Access Compliance Report

Public Rights-of-Way

(Curb Ramps)

Intersection ID: 14633	Main Street: E_KINGSTON_AV	Cross Street: PARK_RD	Location:	W
ADA ID: 0F224C925224	Ramp Type: Perp	Initial Pass/Fail: Fail	Overall Compliance: No	Severity Score: 25
Codes/Mitigation Info/Possible Solution		Field Measurements/Component Compliance

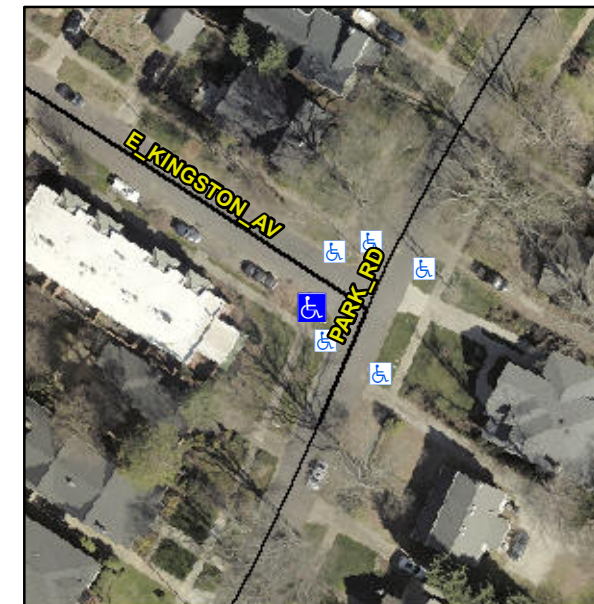
Not Found, R304.2.2

Compliance	Description	Data	Compliance	Description	Data
N/A	Ramp Length (in)	46.0	No	Ramp Slope (%)	15.9
Yes	Ramp Width (in)	60.0	Yes	Ramp XSlope (%)	0.6
N/A	Flare Type LT	N/A	N/A	Flare Type RT	N/A
N/A	Flare Slope LT (%)	N/A	N/A	Flare Slope RT (%)	N/A
N/A	Flare Traversable LT?	N/A	N/A	Flare Traversable RT?	N/A
N/A	Landing Length (in)	N/A	N/A	DWS Provided?	N/A
N/A	Landing Width (in)	N/A	N/A	DWS Contrast?	N/A
N/A	Landing Slope (%)	N/A	N/A	DWS Length (in)	N/A
N/A	Landing X Slope (%)	N/A	N/A	DWS Full Width?	N/A
N/A	Landing Curb? (Y/N)	N/A	N/A	DWS Offset (in)	N/A
N/A	Shared Landing?	N/A			
N/A	Gutter Ponding?	N/A	N/A	Gutter Slope (%)	N/A
N/A	Gutter Lip Ht (in)	N/A	N/A	Gutter X Slope (%)	N/A
N/A	Painted X Walk1?	No	N/A	Painted X Walk2?	N/A
	X Walk 1 Direction	To NE		X Walk 2 Direction	N/A
N/A	X Walk 1 Width (in)	N/A	N/A	X Walk 2 Width (in)	N/A
	X Walk 1 Slope (%)	5.3		X Walk 2 Slope (%)	N/A
	X Walk 1 X Slope (%)	0.9		X Walk 2 X Slope (%)	N/A

Remove & Replace Entire Ramp.
